5.0 ADMINISTRATIVE CONTROLS

The information in this section of the reference ABWR DCD, including all subsections, is incorporated by reference with the following departures and site-specific supplements. The site-specific supplements partially address COL License Information Item 16.1.

FIGURE B 3.3.1.1-1 ADS INHIBIT INSTRUMENTATION CHANNELS

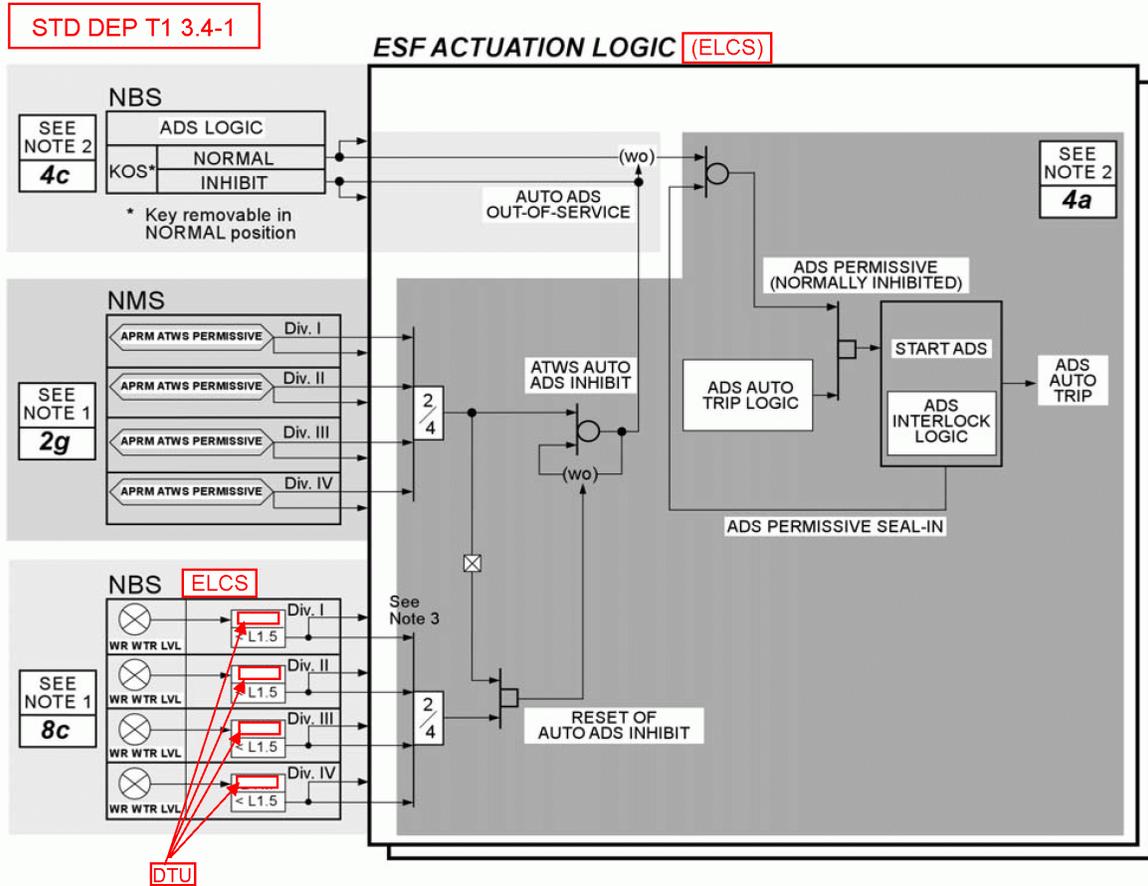
- NOTES:
1. FUNCTION NUMBER AS LISTED IN TABLE 3.3.1.1-1 SSLC SENSOR INSTRUMENTATION
 2. FUNCTION NUMBER AS LISTED IN TABLE 3.3.1.4-1 ESF ACTUATION INSTRUMENTATION
 3. L1.5 DIVISION-OF-SENSORS BYPASS APPLIES TO THIS VOTER

FIGURE B 3.3.1.1-2 RCW/RSW HX ROOM LEAK DETECTION INSTRUMENTATION CHANNELS

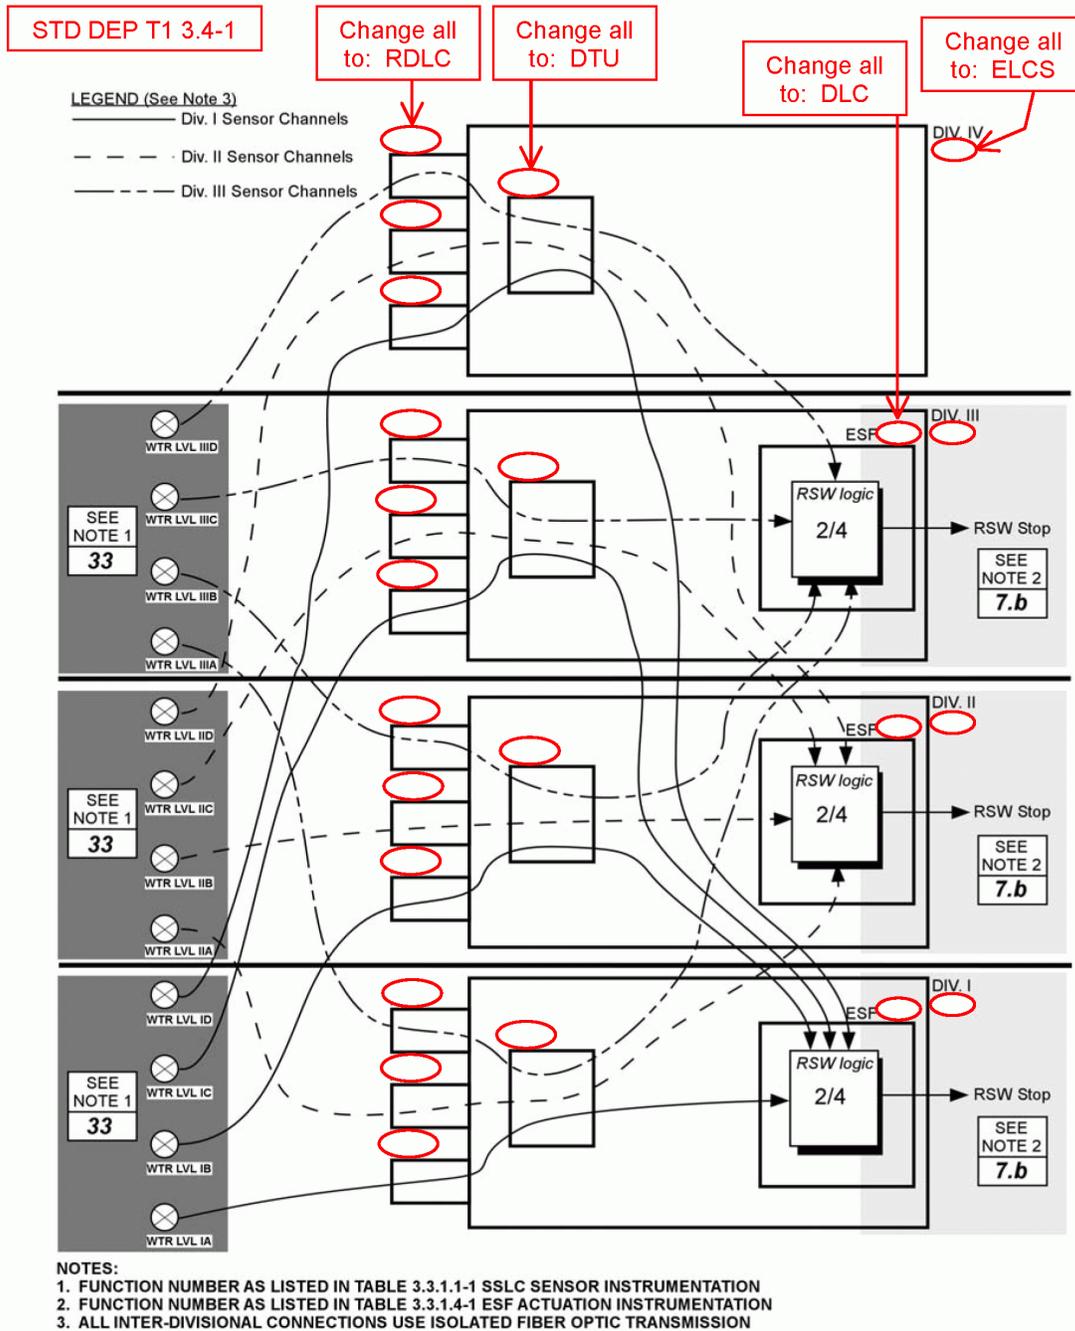
There are four water level transmitters that provide input to the RCW/RSW Heat Exchanger Room Water Level - High Function per RCW/RSW division. The water level data is digitized and transmitted to the ~~DTM~~ DTUs via the ~~EMS~~ ECF.

Figure B 3.3.4.1-1, ATWS and EOC-RPT INSTRUMENTATION CHANNELS

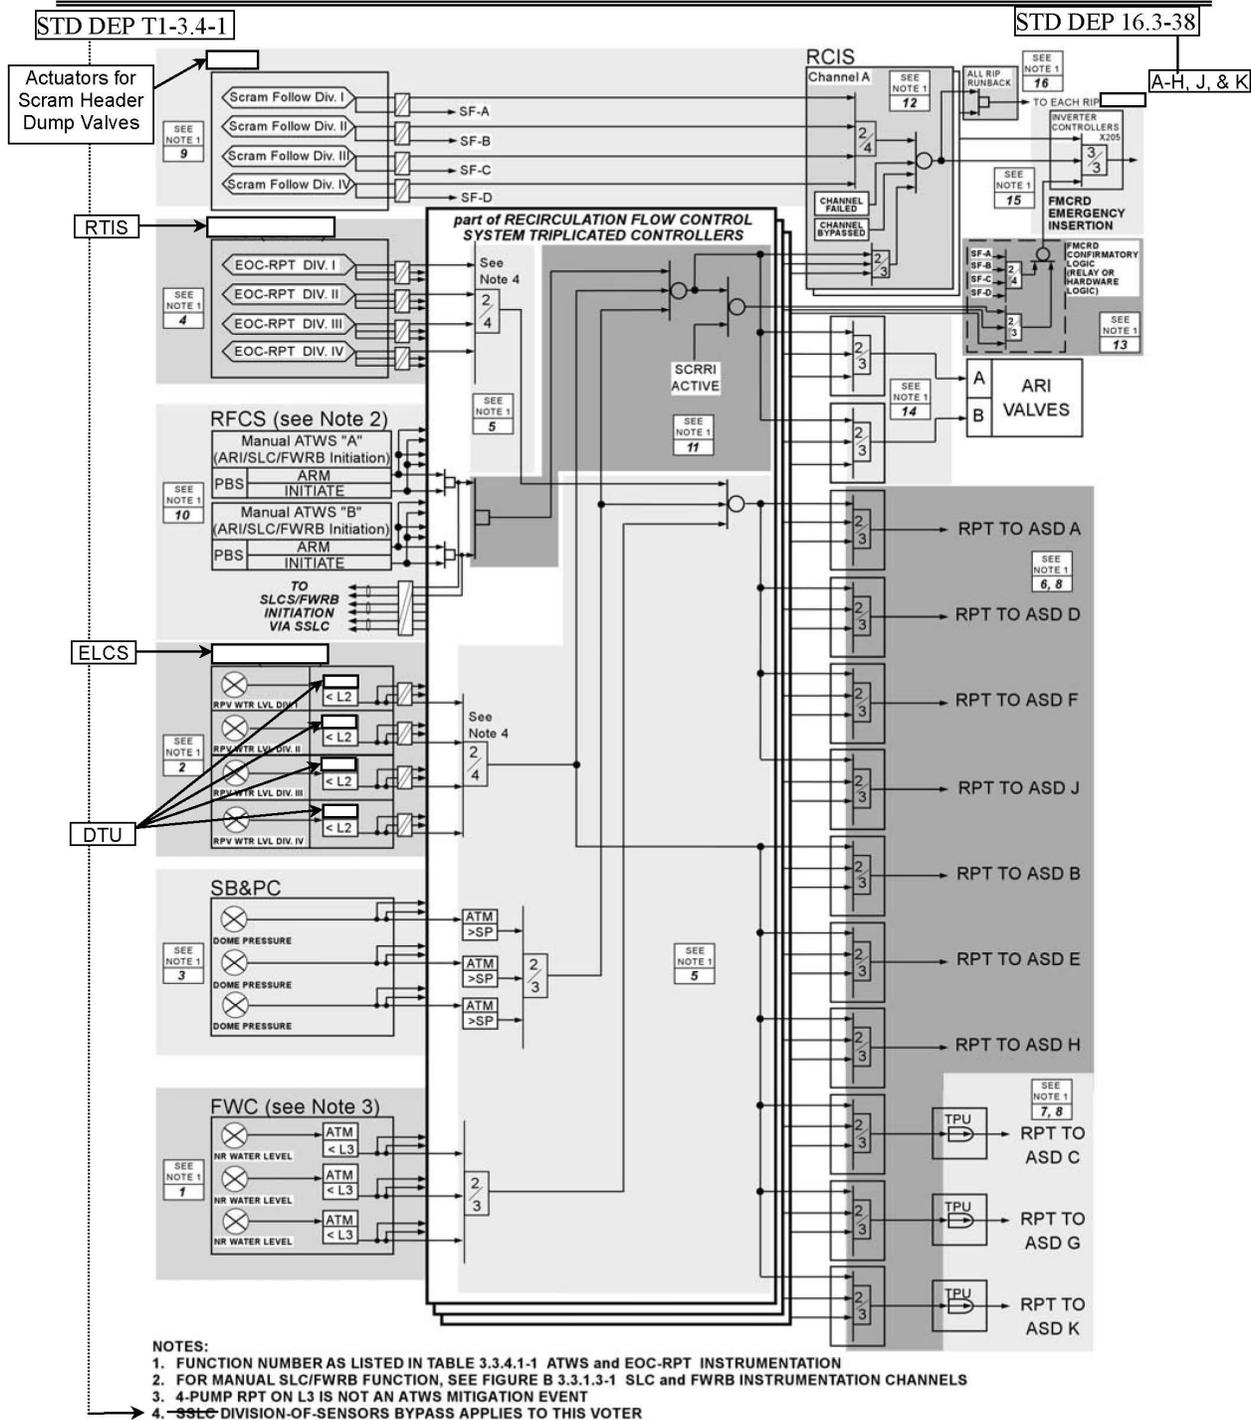
Four channels of Turbine Steam Flow Rapid Shutoff EOC-RPT are available and ~~three~~ are required to be OPERABLE to provide confidence that no single instrument failure can preclude an EOC-RPT from this Function on a valid signal. This Function is considered to be OPERABLE when an EOC-RPT trip signal originating in each of the four ~~SSLC~~ RTIS division channels is received by all three of the RFC controllers.

The trip actuation devices in the ASD are required to be operable in order to complete the RIP trip Function. Each ASD uses signals from the RPT Function in all three of the RFC controllers. A trip condition from any two of the controllers will cause a trip of the associated RIP. ~~Three~~ One channels of pump trip actuation per ASD must be OPERABLE when ATWS mitigation or EOC-RPT is required to be OPERABLE ~~to provide confidence that no single instrument failure can preclude an RPT from this Function on a valid signal.~~
